DA/16702/2007/VCHG/3 - REQUEST TO CHANGE (OTHER) - MATERIAL CHANGE OF USE FOR MULTIPLE DWELLINGS (158 Dwellings) AND FOOD AND DRINK OUTLET LOCATED AT 2 & 8 GAYUNDAH ESP, WOODY POINT - Division 6

## 2-8 Gayundah Esplanade

Council RFI Response 13th September 2019

4.0 Building Height, Bulk and Scale 4.02 Clause 1 - Setback Area Comparison

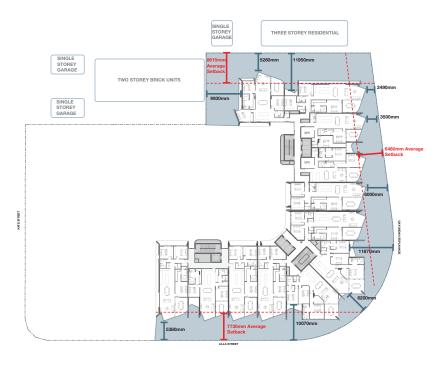
#### **RFI Clause 1**

The applicant's Town Planning Report states "It is noted that the existing building is approved with a maximum RL 39.1m AHD or 10 storeys. The approved built form is bulky and extends across the length of all three street frontages. The proposed changes offers an improved built form which despite having a higher aspect, does overall reduce the bulk and scale of the development as it presents in the locality."

#### LODGED SCHEME

Apartment Building Setback Area - 1137m<sup>2</sup>

4.0 Building Height, Bulk and Scale 4.06 Clause 1 - Height Comparison

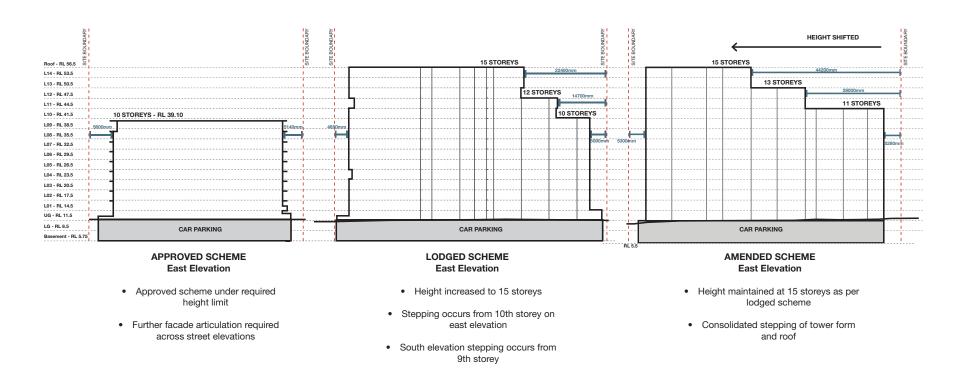
#### **RFI Clause 1**

The applicant's Town Planning Report states "It is noted that the existing building is approved with a maximum RL 39.1m AHD or 10 storeys. The approved built form is bulky and extends across the length of all three street frontages. The proposed changes offers an improved built form which despite having a higher aspect, does overall reduce the bulk and scale of the development as it presents in the locality."

#### **HEIGHT COMPARISON STUDY**

5.0 Building Design / 5.02 Clause 2A - Lodged Scheme Plan Design

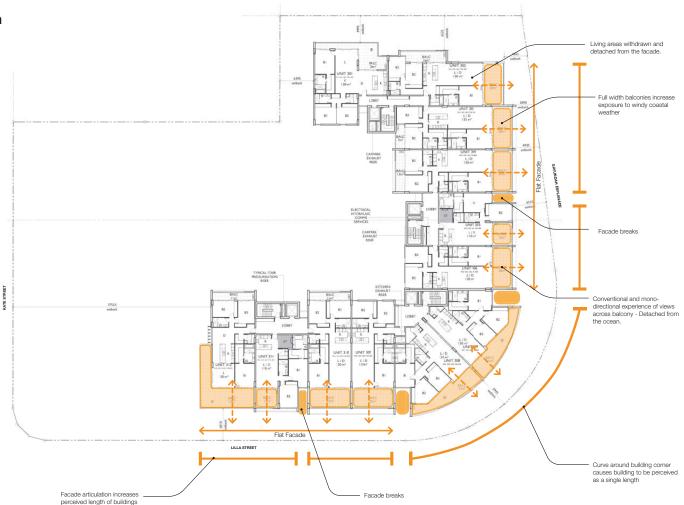
#### **RFI Clause 2A**

- Broad width to corner
- Additional facade articulation required
- · Lack of clarity in massing and breaks
- Withdrawn living areas
- · Exposed balconies to wind and weather
- Dominance of Balconies Lack of variance in facade

5.0 Building Design 5.07 Clause 2B - Approved Massing Arrangement

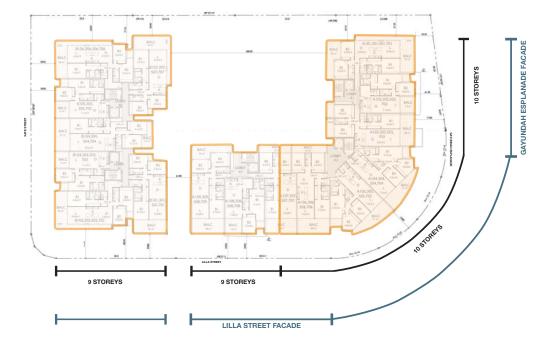
#### **RFI Clause 2B**

Tall buildings are required to provide architectural variation through a distinct top, middle and base section.

- Length of building around corner of Gayundah Esplanade and Lilla
- Curved corner increases perceived building length
- Hard edge presented to streetscape across full site boundary

6.0 Connectivity and Pedestrian Interface 6.01 Clause 4A & 4B - Approved and Lodged Scheme Ground Plane

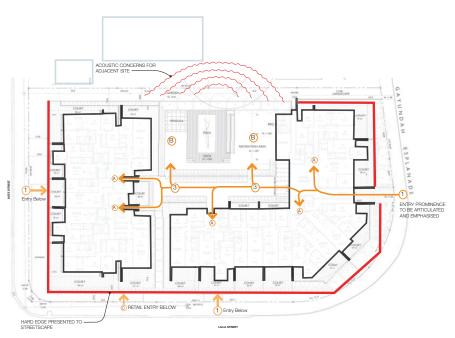
#### **RFI Clause 4A**

Provide updated proposal plans and landscape concept plans which demonstrate the provision of a 2m wide pedestrian path abutting the property boundary. The remaining verge is to be grassed.

#### **RFI Clause 4B**

Provide amended plans which demonstrate an improved pedestrian interface at the corner of Gayundah Esplanade and Lilla Street. Options may include the use of a ramped entry, stepped planting to reduce the height of the boundary wall at this location.

6.0 Connectivity and Pedestrian Interface 6.02 Clause 4A & 4B - Amended Scheme Ground Plane

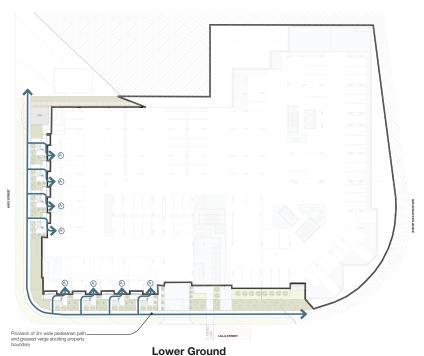
#### **RFI Clause 4A**

Provide updated proposal plans and landscape concept plans which demonstrate the provision of a 2m wide pedestrian path abutting the property boundary. The remaining verge is to be grassed.

#### **RFI Clause 4B**

Provide amended plans which demonstrate an improved pedestrian interface at the corner of Gayundah Esplanade and Lilla Street. Options may include the use of a ramped entry, stepped planting to reduce the height of the boundary wall at this location.

## and vegetation better located to act as an acoustic barrier and mproved corner interface through stepped planting and clear entry definition -Reducing height of boundary Provision of 2m wide pedestrian

- Clear and defined entry sequence from corner of Gayundah Esplanade and Lilla Street
- Permeable and pedestrian friendly around plane
- Logical wayfinding integrated with landscape and communal spaces
- High visibility to communal recreation from entry lobby
- Expression of boat replica defines the corner of the scheme

7.0 Landscaping 7.01 Clause 5 - Amended Scheme Deep Planting

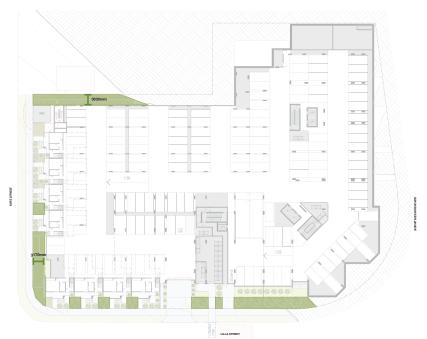
#### **RFI Clause 5**

The Town Planning Report notes that the development provides 12% deep planting and complies with the Residential Uses Code Example E10.2 that deep planting areas have a minimum dimension of 4m. Please provide a dimensioned Landscape Concept Plan identifying the nominated deep planting areas, noting that they must be clear of the basement.

**TOTAL DEEP PLANTING AREA - 845sqm (12.2%)**

Note: Refer to Landscape Architect Report for detailed response to Council RFI

7.0 Landscaping 7.02 Clause 6 - Amended Scheme Landscape Plan

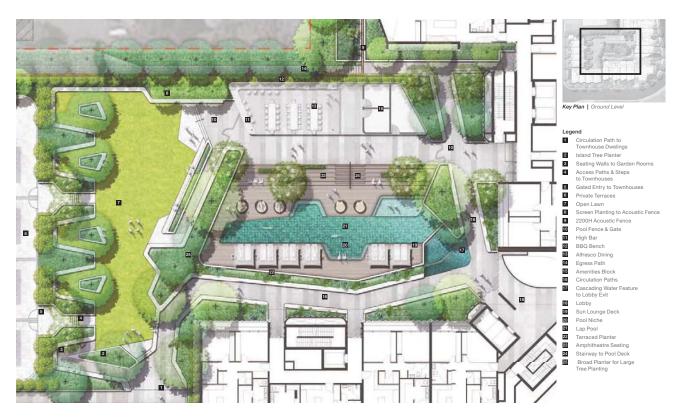
#### **RFI Clause 6**

With reference to the Planning Scheme Policy - Residential Design section 6.7 Landscaping, provide information demonstrating that the proposed landscaping:

- Integrates with the overall site layout and building design; Information Request - Development Application No. DA/16705/2007/VCHG/3
- Reduces the urban heat island effect and enhances and improves micro-climate conditions;
- Contributes to local biodiversity;
- Enables planting of large trees on site; and
- Integrates water sensitive urban design.

Note: Refer to Landscape Architect Report for detailed response to Council RFI

8.0 Staging 8.01 Clause 7 & 8 - Amended Staging Diagram

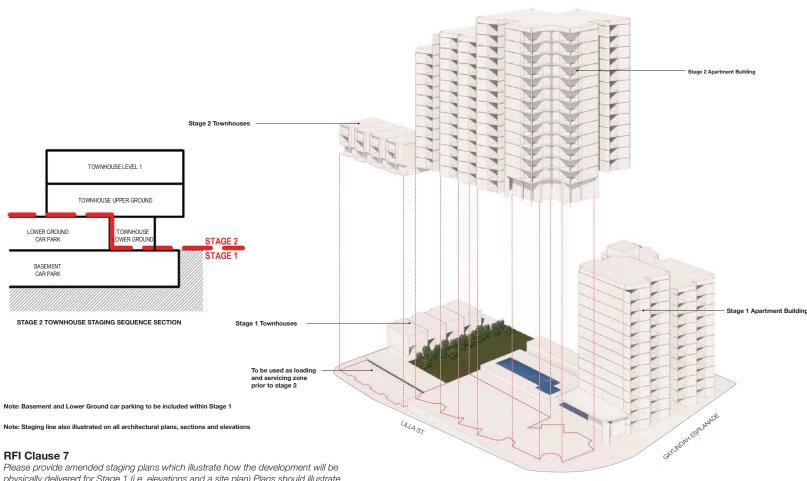
physically delivered for Stage 1 (i.e. elevations and a site plan) Plans should illustrate the visual appearance of the built form and indicative landscaping for Stage 1.

#### **RFI Clause 8**

The proposed town houses are represented in the town planning report as a positive aspect of the proposal. In this respect, these should be delivered in stage 1.

8.0 Staging 8.03 Clause 7 & 8 - Amended Staging Plans

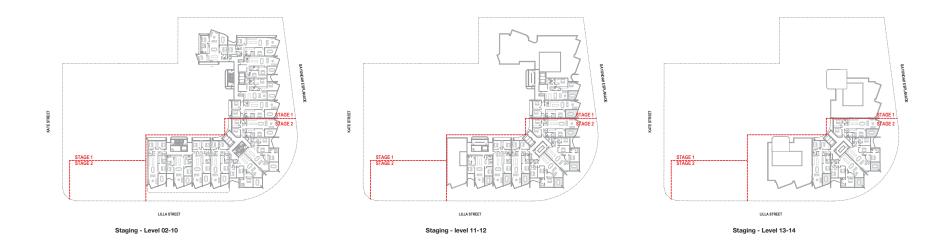
#### **RFI Clause 7**

Please provide amended staging plans which illustrate how the development will be physically delivered for Stage 1 (i.e. elevations and a site plan) Plans should illustrate the visual appearance of the built form and indicative landscaping for Stage 1.

#### **RFI Clause 8**

The proposed town houses are represented in the town planning report as a positive aspect of the proposal. In this respect, these should be delivered in stage 1.

Note: Staging line also illustrated on all architectural plans, sections and elevations
